RE: Notice of Availability (NOA) of a Draft Environmental Impact Report (DEIR) -
Relocation El Granada Fire Station 41

Paul Cole
Fire Station 41 Replacement
Draft EIR - State Clearing House #2015062089
January 18, 2017

TABLE 5-1 COMMENTS AND RESPONSE MATRIX

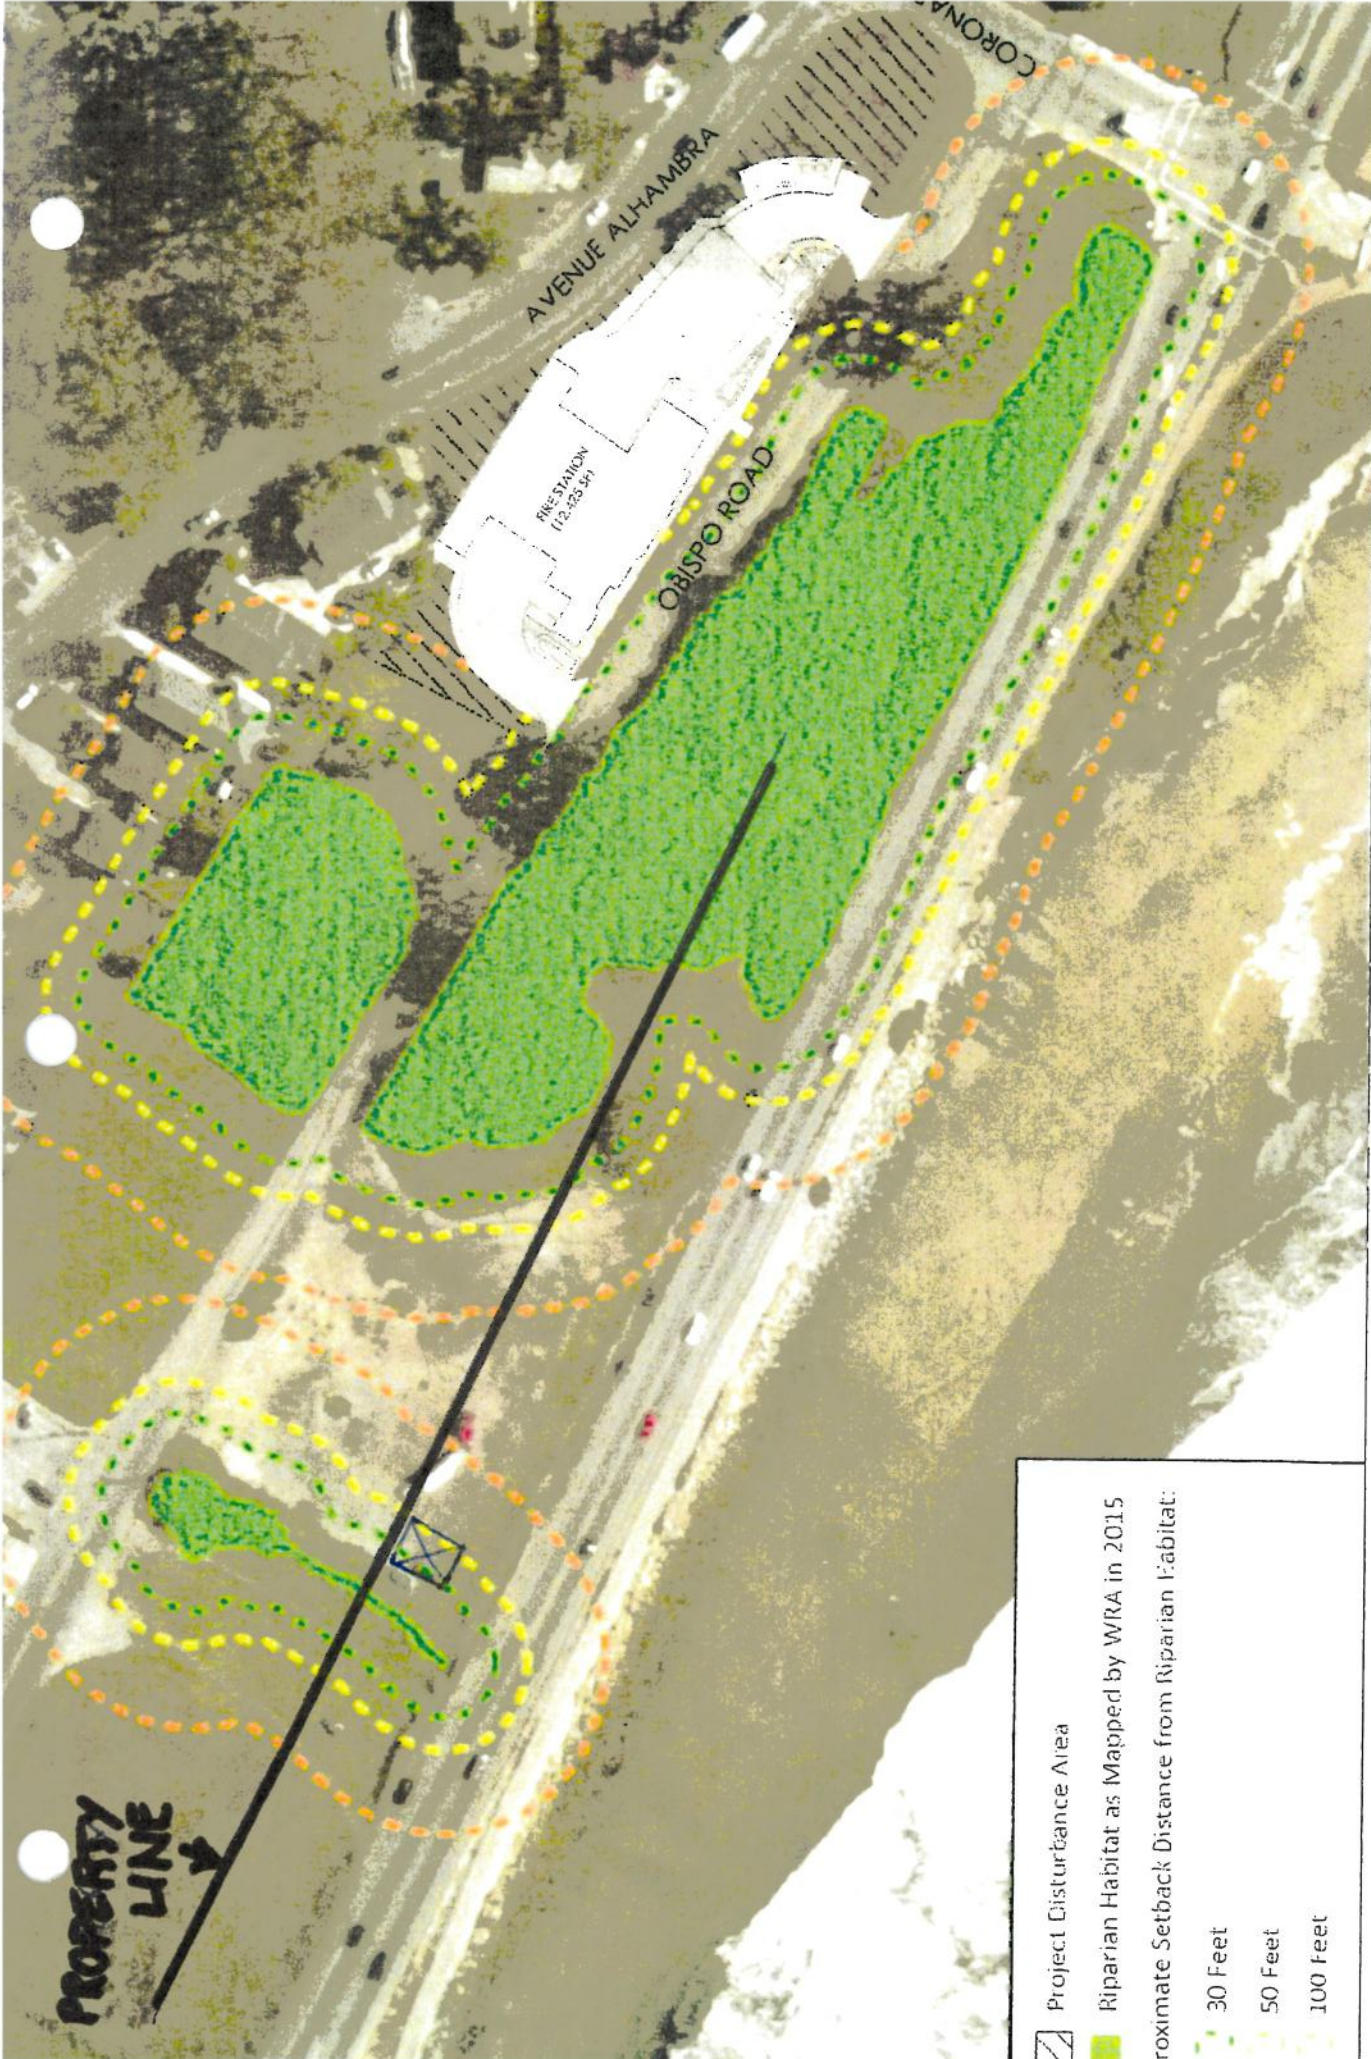
The DEIR states that Figure 4.3-1 shows the location of the riparian corridor on the site relative to the "footprint" of the proposed project. The applicant should revise this figure so that one can see exactly where the structures and other development will be sited on the parcel in relation to the riparian habitat

and buffer. They should add an overlay of the proposed site plan onto Figure 4.3-1, for clarity and to show whether or not the buffers meet LCP Policy 7.11 requirements.

Comment #	Date	Comment	Response
A01-04		The DEIR states that Figure 4.3-1 shows the location of the riparian corridor on the site relative to the "footprint" of the proposed project. The applicant should revise this figure so that one can see exactly where the structures and other development will be sited on the parcel in relation to the riparian habitat and buffer. They should add an overlay of the proposed site plan onto Figure 4.3-1, for clarity and to show whether or not the buffers meet LCP Policy 7.11 requirements.	Figure 4.3-1, as shown in Chapter 3 of this Final EIR, has been updated to show the approximate location of the development footprint of the project in relation to the riparian habitat and buffer zones.
A01-05		Appendix A, the Initial Study (WRA Environmental Consultants' assessment) suggests that the stream is intermittent; therefore, a 30-foot buffer is applicable. The TRA Environmental Sciences letter, however, indicates there was hydrology in August 2014 suggesting that the drainage is perennial. We recommend that the 50-foot, rather than a 30-foot, buffer be applied. It appears that the 50-foot buffer will not preclude the development as proposed, and will ensure protection of the resource as required by the LCP.	As stated on page 4.3-23 of the Draft EIR, and as shown in the updated Figure 4.3-1 included in Chapter 3 of this Final EIR, the footprint of the new structures and other improvements would be located more than 50 feet from the edge of the riparian habitat on the site. The proposed driveways would be located within the 50-foot buffer, and would connect to the existing Obispo Road within a previously disturbed and developed roadbed. As such, the project complies with the buffer zone requirements set forth in LCP Policy 7.11, regardless of whether the unnamed drainage is considered an intermittent or perennial stream.
